February 24, 1967

SPARK PLUG CABLE GUIDE - 1967 SPORTSTER MODEL XLCH

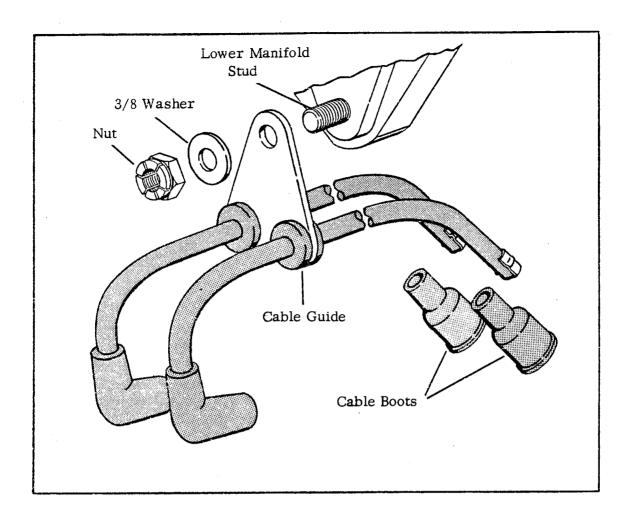
New spark plug cable guide, part No. 31630-67, is being installed on all XLCH motorcycles at the factory starting with engine serial No. 67XLCH 3989. This guide is used to hold cables in the correct position away from carburetor to prevent possible cable interference with the carburetor throttle lever.

The cable guide is mounted on carburetor manifold lower stud. Ignition cables pass through grommets in holes of insulating material.

Remove horn bracket mounting nut on left side of motorcycle and drop horn out of the way. Remove 3/8" nut from lower manifold stud and install cable guide. Use a 3/8" flat washer against cable guide when reinstalling nut. Remove cable boots and cable ends from magneto towers. Remove cable boots and thread cables through grommets in cable guide. Reinstall boots, cables in towers, and horn bracket.
